Fire Risk Assessment

Property assessed:	9-10 Longlands View Kendal LA9 6HJ
Client:	South Lakes Housing
UPRN:	1101-2
Property Classification:	Level 3
Document Print Date:	07/02/2019

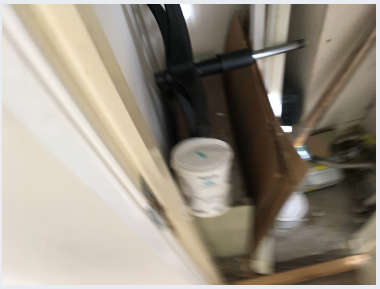
Question	G.2	Comment: Combustible items were noted close to an ignition source. First floor service cupboard was being used for resident's storage

Section	House-Keeping			
Action ID	171246			
Quantity - Known - Potential	 N/A N/A	Recommendation: All combustible items should be removed from the electrical intake cupboard and the door kept locked.		
Priority	Man1	Due Date: 07/03/2019	Status: Not Complete

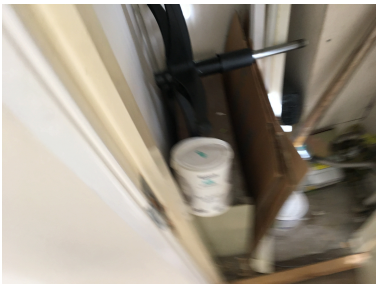
Question - G.2: Are combustible items kept clear from sources of ignition such as electrical equipment?	No
Comment: Combustible items were noted close to an ignition source. First floor service cupboard was being used for resident's storage	
Recommendation: All combustible items should be removed from the electrical intake cupboard and the door kept locked.

Priority: Man1	Known Quantity: N/A	Potential Quantity: N/A	Action ID: 171246
